CITY AND BOROUGH OF SITKA

MEMORANDUM

To: Chair Windsor and Planning Commission Members
From: Amy Ainslie, Planning & Community Development Director
Date: May 20, 2026
Subject: Amendment to Plat Note 8 of the Su'S Heeni Shaak Subdivision

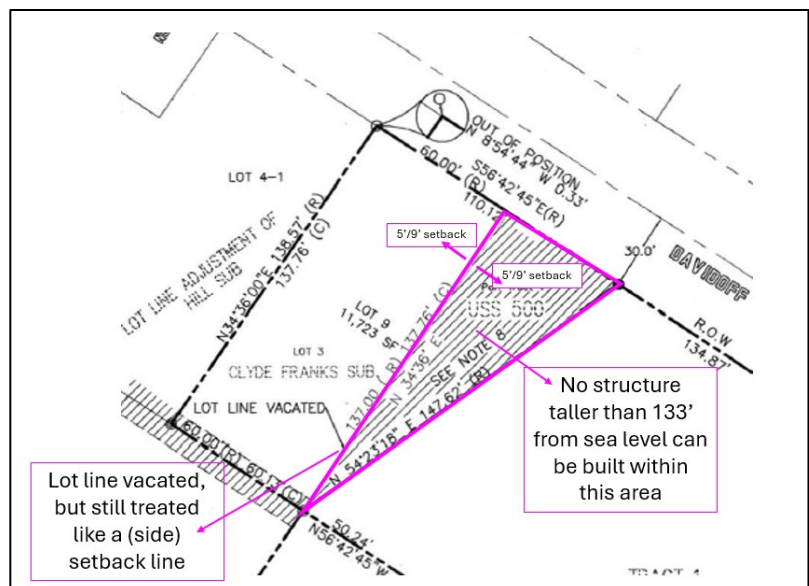
"That portion of Tract 1, USS 500 being a part of the newly created Lot 9 (expanded lot 3) on this subdivision is subject to a build height restriction. No structure shall be placed on this portion (only) of Lot 9 which would rise above 133 ft from sea level (MLLW = 0.0') - the same height as the existing northwesterly most property corner. Also, the setback along the original Lot 3 Southeast lot boundary remains in effect. The expanded area will not influence the location of the setback line along this boundary."

The restrictions of this plat note are demonstrated in the graphic here. The side property line, though dissolved, is essentially still in effect for the purposes of setbacks.

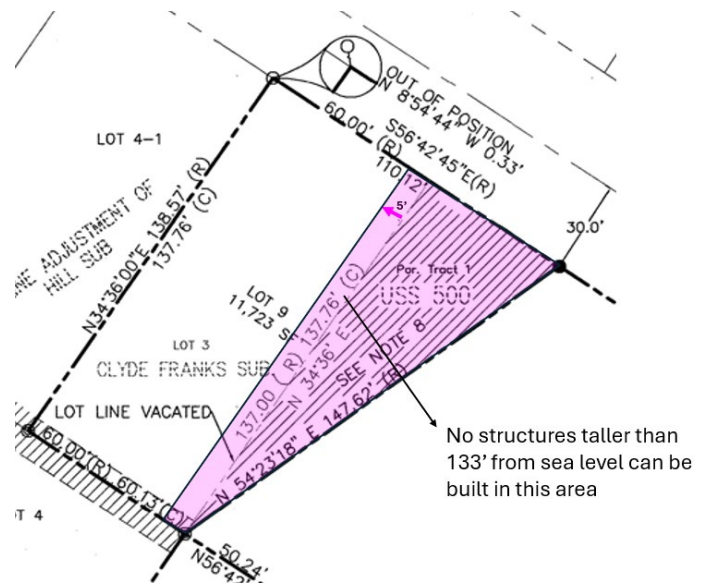
Staff believes the intent of this amendment to plat note #8 is to allow the property owner to build within the “retained setback” on the former Lot 9, but also limit this area to the building height restriction. However, given that in the zoning code no structures taller than 30” above grade can be built in a setback, the retention of this setback but allowing structures within it is confusing and would be difficult to administer in the future. Staff instead suggests the following verbiage & diagram:

*“That portion of Tract 1, USS 500 being a part of the newly created Lot 9 (expanded Lot 3) on this subdivision, **as well as five feet west of the common boundary line between the former Lot 3 and Portion of Tract 1 dissolved per the Su’S Heeni Shaak Subdivision,** is subject to a build height restriction. No structure shall be placed on this portion (only) of Lot 9 which would rise above 133 ft from sea level (MLLW = 0.0') - the same height as the existing northwesterly most property corner. **Also, the setback along the original Lot 3 Southeast lot boundary remains in effect. The expanded area will not influence the location of the setback line along this boundary.”***
